Engineering Change Order (ECO)

ECO Number: 7f881e81-2a8c-4a0b-8fd2-23214d4c62cc

Change Summary

ISO_LEFT [MATCHED]

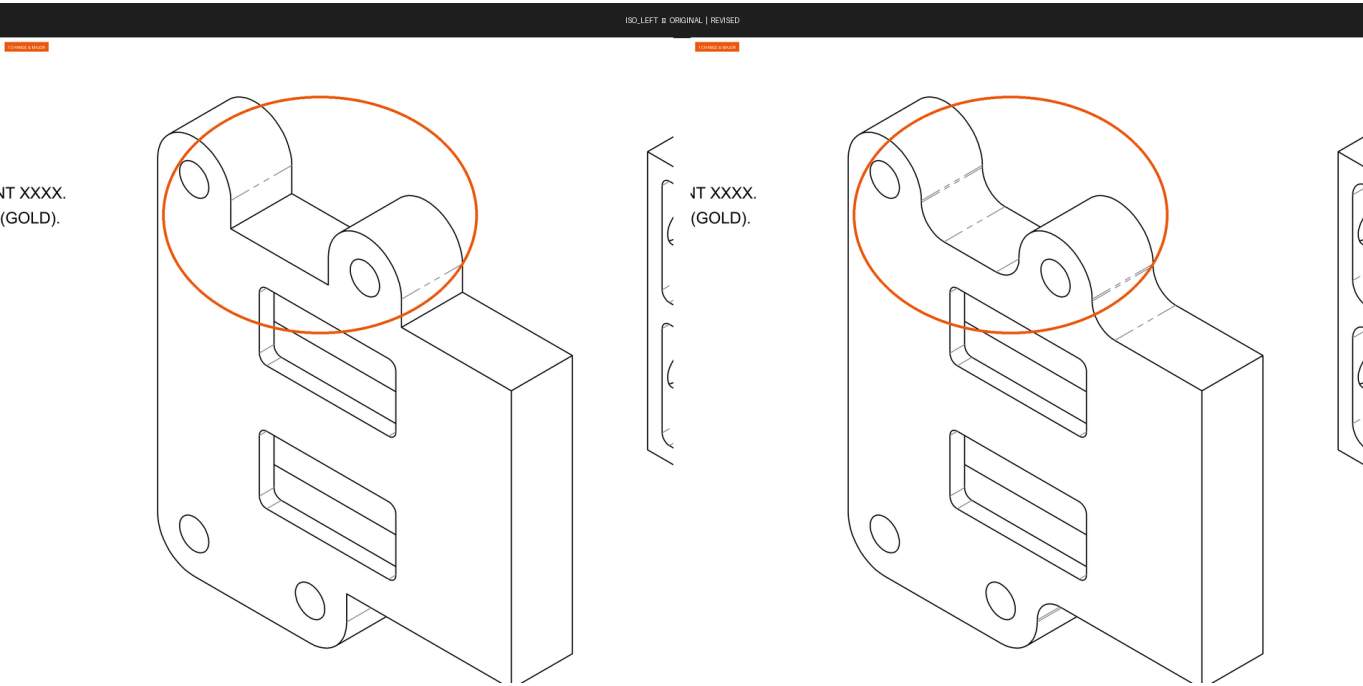
#	Component / Area	Description of Change
The upper hinge bridge geometry changed from a flat-topped rectangular profile to a curved radiused profile.	The upper hinge bridge geometry changed from a flat-topped rectangular profile to a curved radiused profile.	The upper hinge bridge geometry changed from a flat-topped rectangular profile to a curved radiused profile.

ISO_RIGHT [MATCHED]

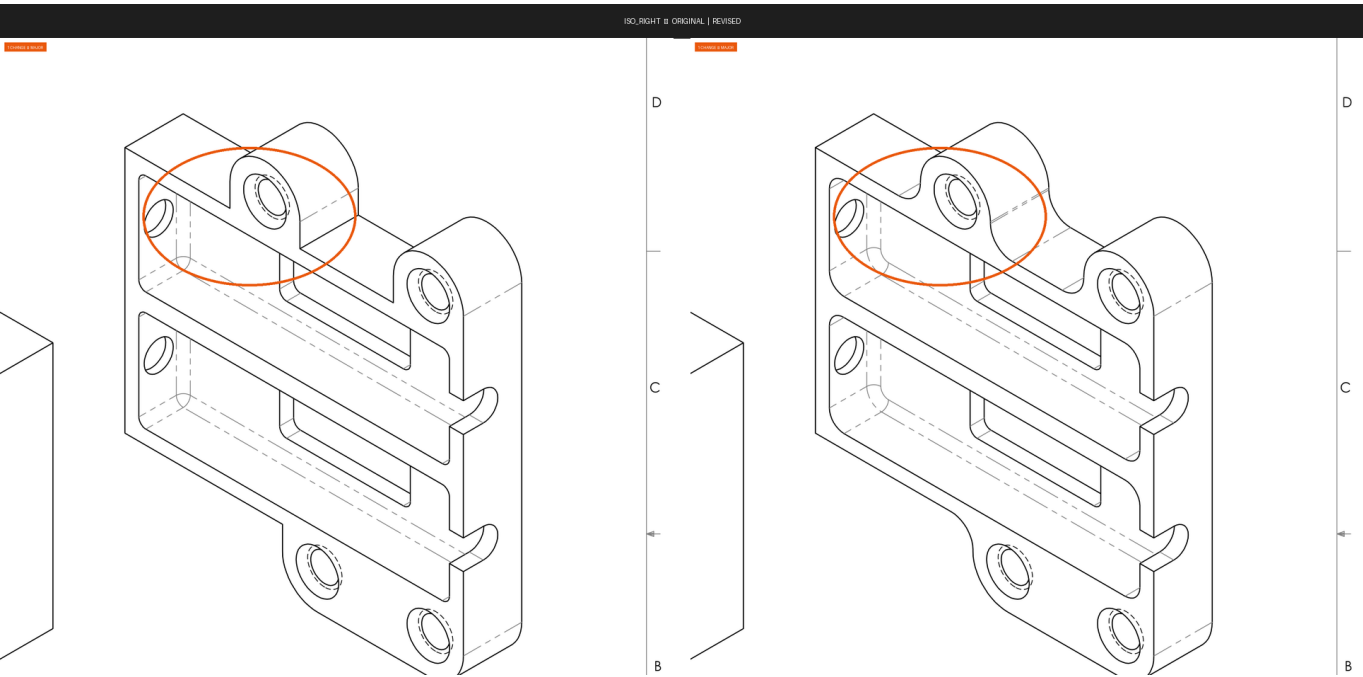
#	Component / Area	Description of Change
A raised step feature on the upper-left top face is removed in the revised drawing.	A raised step feature on the upper-left top face is removed in the revised drawing.	A raised step feature on the upper-left top face is removed in the revised drawing.

SECTION B-B [MATCHED]

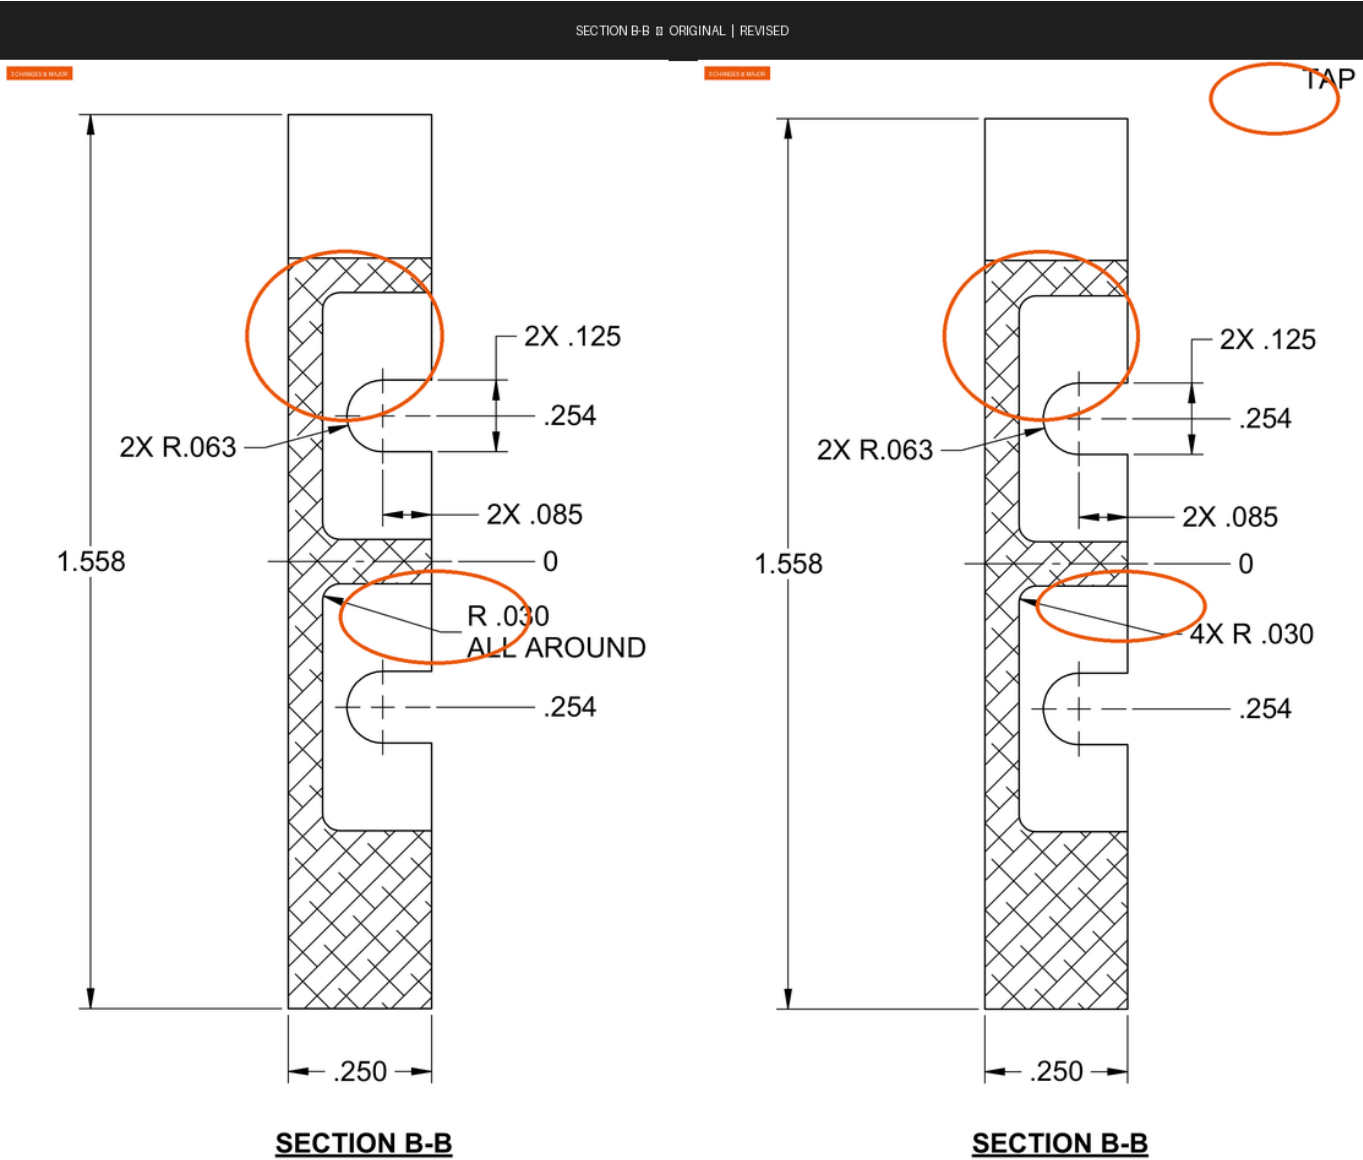
#	Component / Area	Description of Change
Radius callout changed from 'ALL AROUND' to '4X R .030' specifying discrete count instead of continuous application.	Radius callout changed from 'ALL AROUND' to '4X R .030' specifying discrete count instead of continuous application.	Radius callout changed from 'ALL AROUND' to '4X R .030' specifying discrete count instead of continuous application.
New 'TAP' annotation added in upper-right corner of the revised view.	New 'TAP' annotation added in upper-right corner of the revised view.	New 'TAP' annotation added in upper-right corner of the revised view.
Upper slot top corners appear changed from rounded to square in the revised drawing.	Upper slot top corners appear changed from rounded to square in the revised drawing.	Upper slot top corners appear changed from rounded to square in the revised drawing.

FRONT_VIEW [MATCHED]

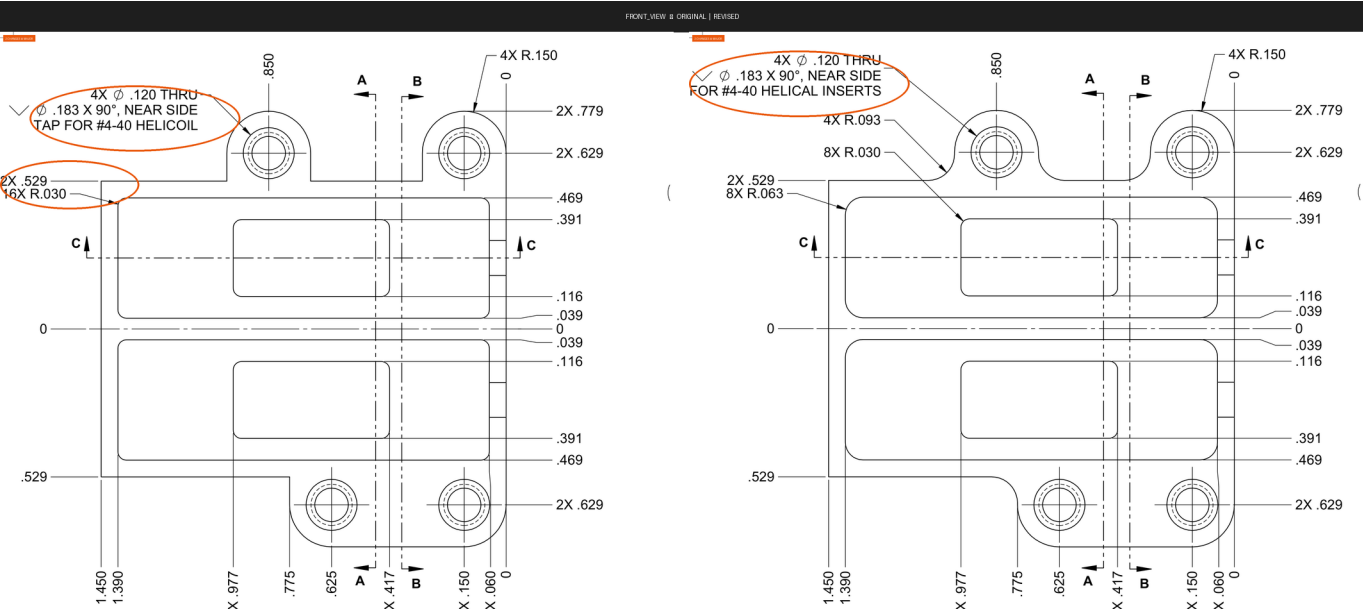
#	Component / Area	Description of Change
Insert specification text changed from HELICOIL to HELICAL INSERTS.	Insert specification text changed from HELICOIL to HELICAL INSERTS.	Insert specification text changed from HELICOIL to HELICAL INSERTS.
16X R.030 radius callout was removed from the revised drawing.	16X R.030 radius callout was removed from the revised drawing.	16X R.030 radius callout was removed from the revised drawing.

SECTION A-A [MATCHED]

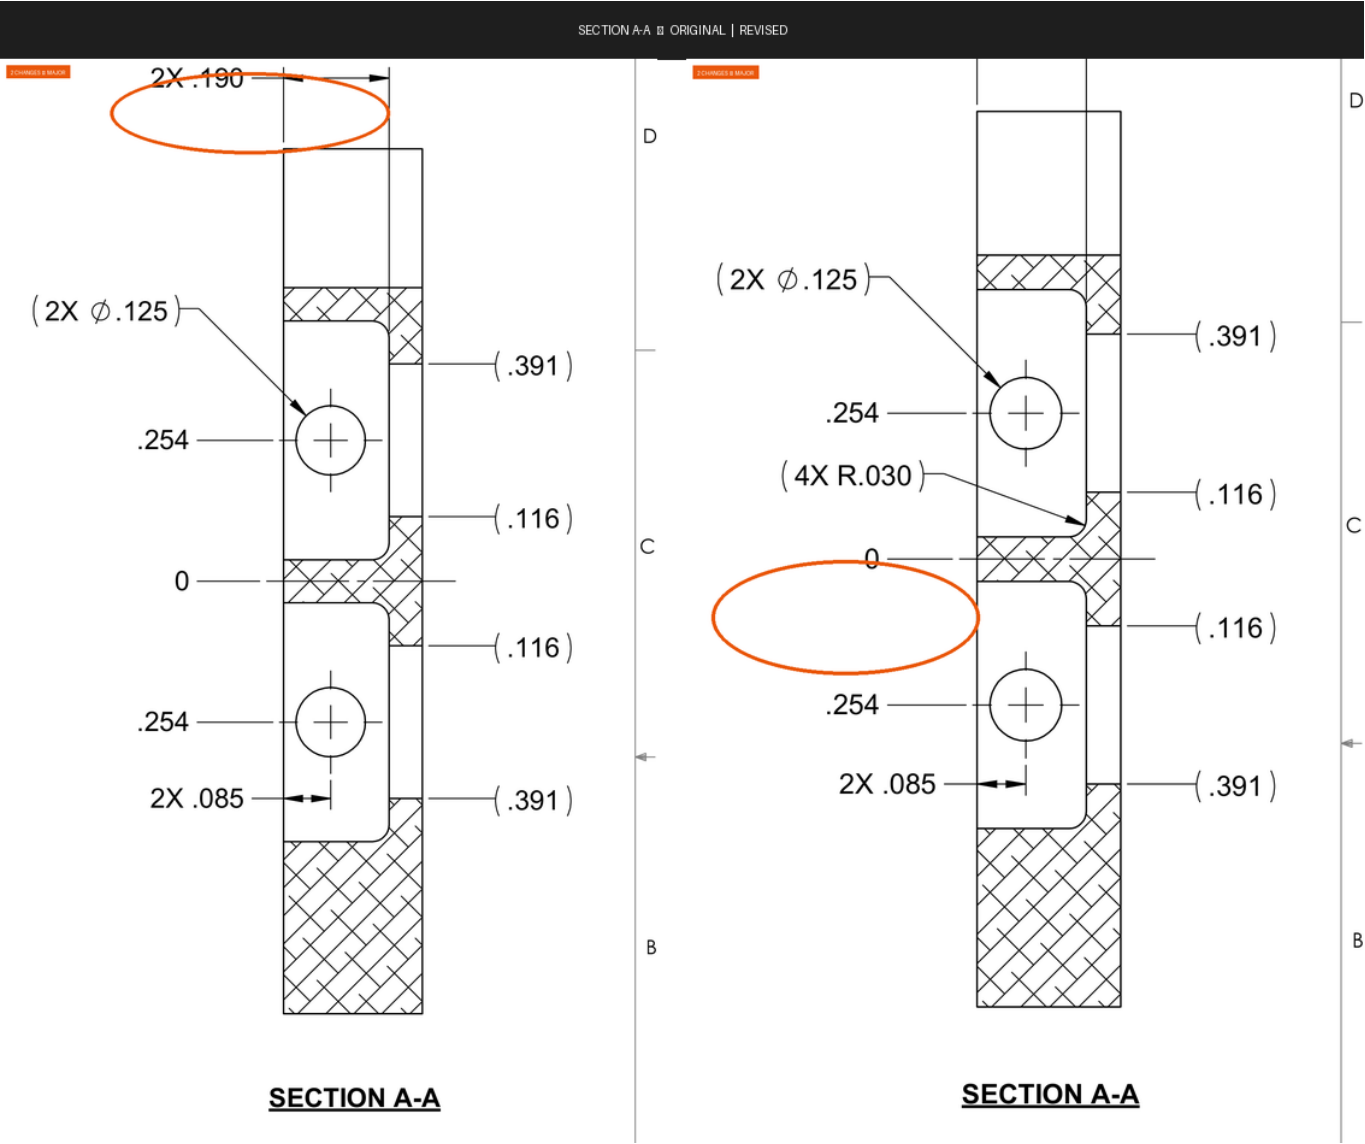
#	Component / Area	Description of Change
New reference callout for 4X R.030 corner radii was added to the pocket features.	New reference callout for 4X R.030 corner radii was added to the pocket features.	New reference callout for 4X R.030 corner radii was added to the pocket features.
The 2X .190 width dimension at the top of the view was removed.	The 2X .190 width dimension at the top of the view was removed.	The 2X .190 width dimension at the top of the view was removed.

SECTION C-C [MATCHED]

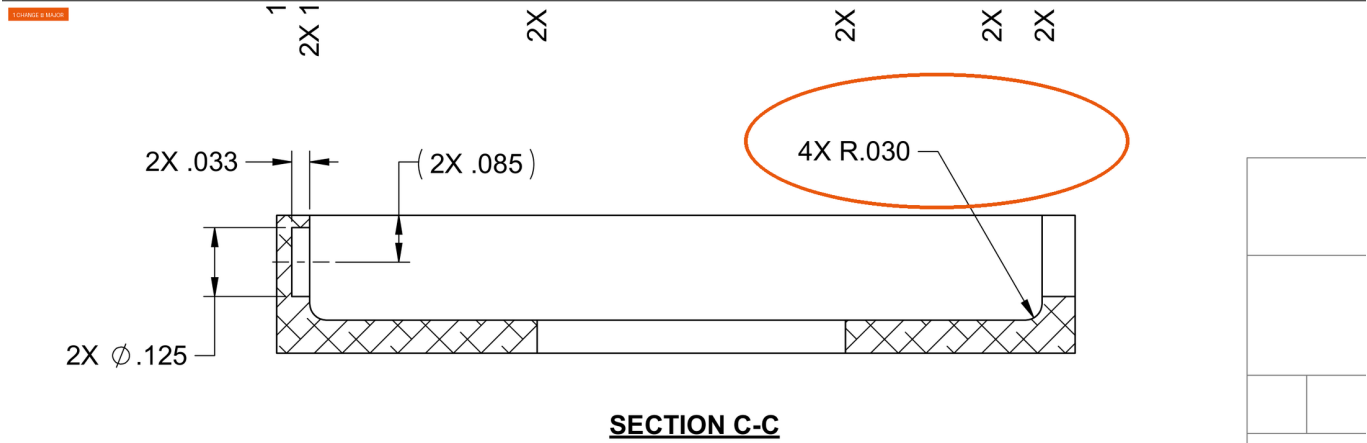
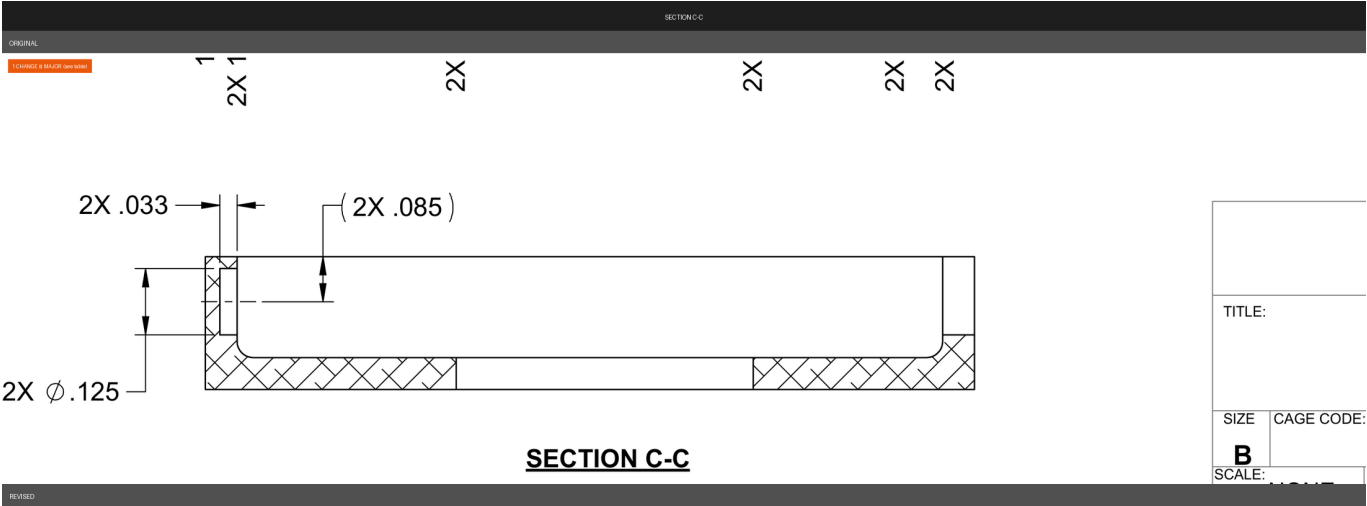
#	Component / Area	Description of Change
New radius callout 4X R.030 added to corner features in the section view.	New radius callout 4X R.030 added to corner features in the section view.	New radius callout 4X R.030 added to corner features in the section view.
